## Development Review Team Comments

**Project Number:** RCU2023-00001

**Project Name:** GCSA Event Center Conditional Use Permit Full Barn

**LANDSCAPE PLAN**

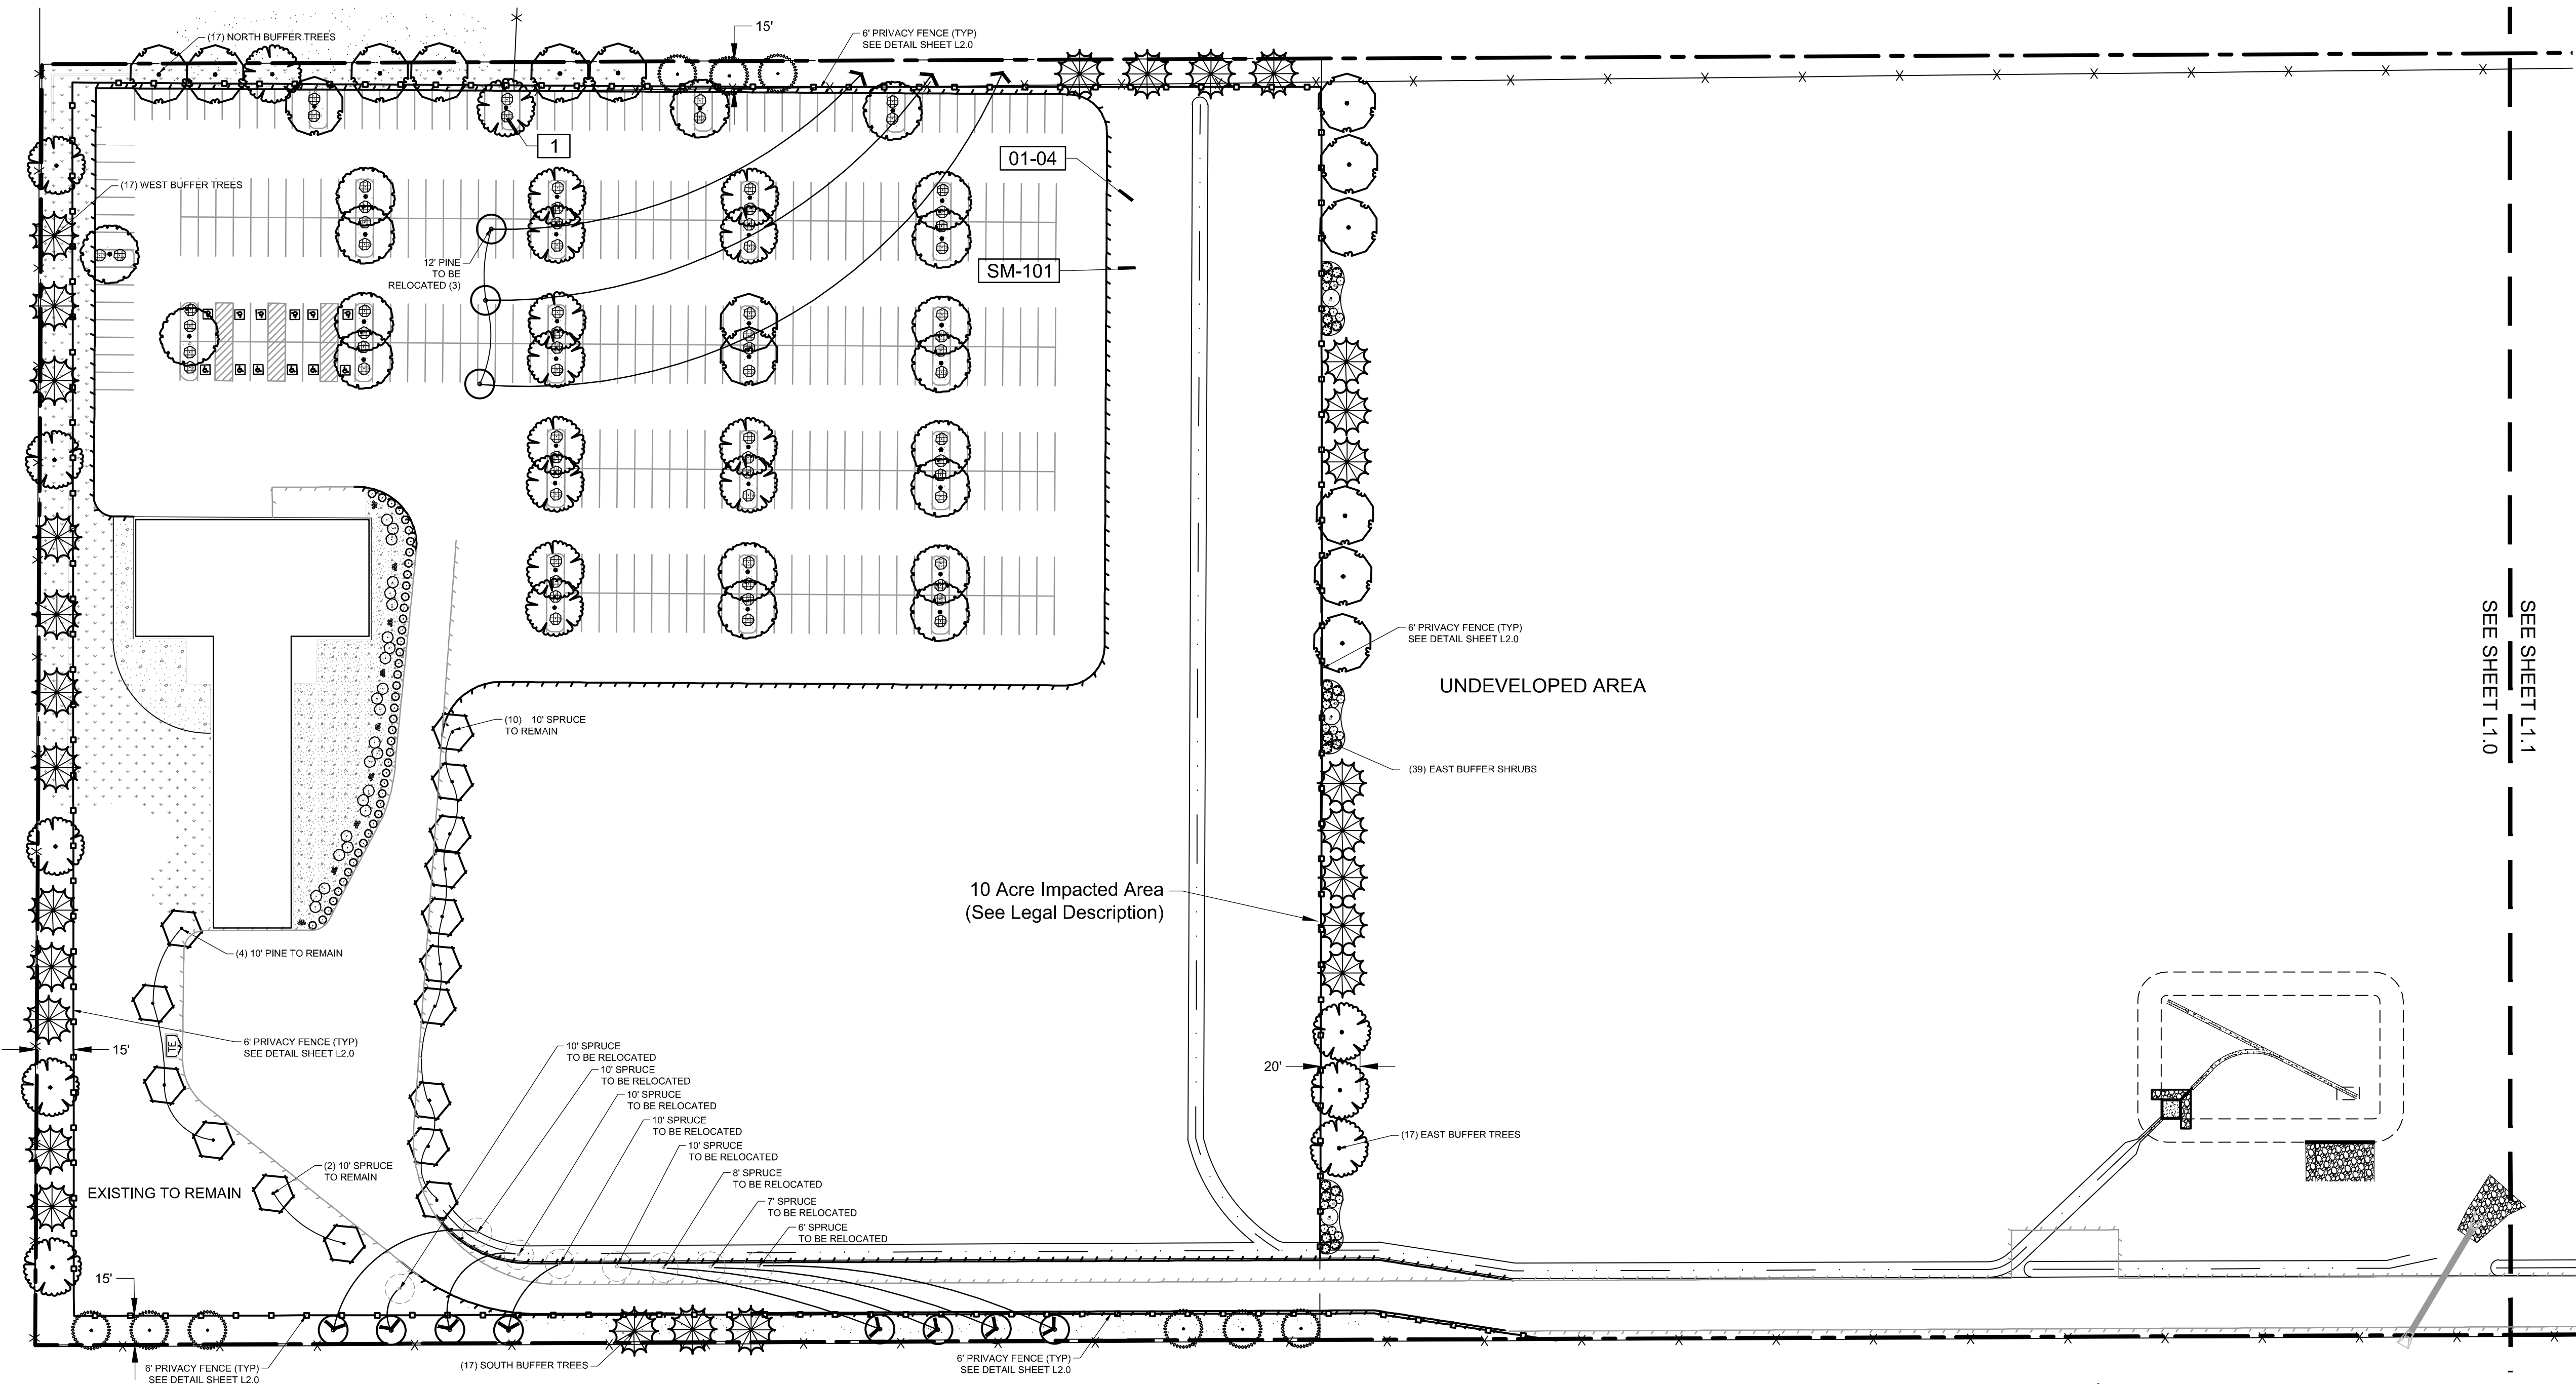
PLN1: I see the landscape plan with the revisions. Why does the southern border of the bufferyard not have the required trees along the bufferyard in the designated spaces but has arrows indicating future positioning? Please put tree images where they will be planted. **NDS Response: All the required trees will be provided. These are existing large evergreen trees that will be relocated to satisfy the code requirements. Tree symbols for the transplanted trees have been moved to the location that they will be transplanted to. A dashed circle has been used to designate the original location.**
